### Lindfield Learning Village - Stages 2 and 3 - Amended Scheme

#### Submission on behalf of Strata Plan 90970

Photo 19 - Semi trailer attempted to drive into Dunstan Grove residences and became wedged.

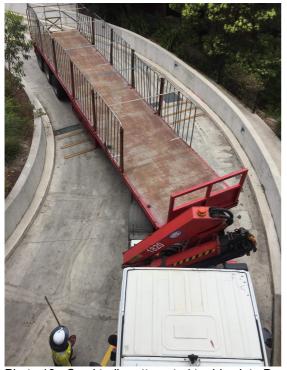
- a standard car travelling in the opposite direction. Dunstan Grove receives many visits from delivery vehicles, moving vans, rubbish trucks and the like. It has not been demonstrated how these vehicles will be able to pass safely.
- Other sections of the RTS documents refer to the Loop Road being used by 14.5m coaches for school excursions. These have not been demonstrated in the swept path analysis.
- The Construction Management plan proposed that all deliveries (semi trailers etc) will also pass down this road (refer Photo 19). No consideration of swept paths for these vehicles has been done.
